MIL-V-2D
 AMENDMENT 3
18 February 1981
 SUPERSEDING
 AMENDMENT 2
 10 August 1973

MILITARY SPECIFICATION

VALVES, CYLINDER, GAS

This amendment forms a part of Military Specification MIL-V-2D, dated 9 September 1970, and is mandatory for use by all Departments and Agencies of the Department of Defense.

FIGURE 1a. CAP AND PLUG

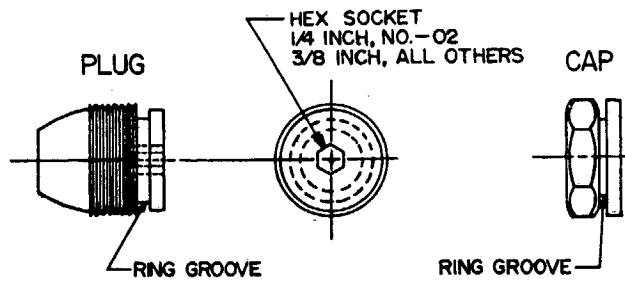
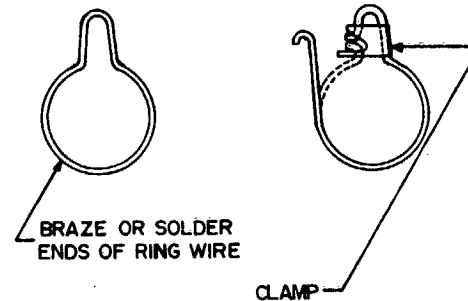
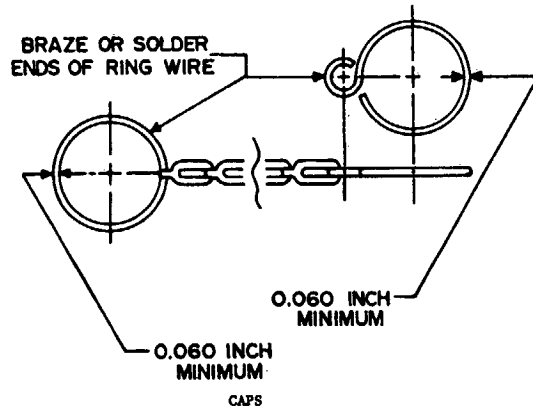
"3.9.8 Outlet cap and plug. When specified, valves with threaded outlets shall have a permanent metal mating plug or cap in accordance with figures 1a and 1 b. The metal plug or cap shall be supplied with retaining chain and clip to secure the plug or cap to the valve. The metal plug or cap shall effectively seal the valve against leakage when tested as specified herein."

3.9.8.1, line 8, delete period after "threads" and add: "in accordance with figures 1a and 1b."

Following page 42 add figures 1a and 1b.
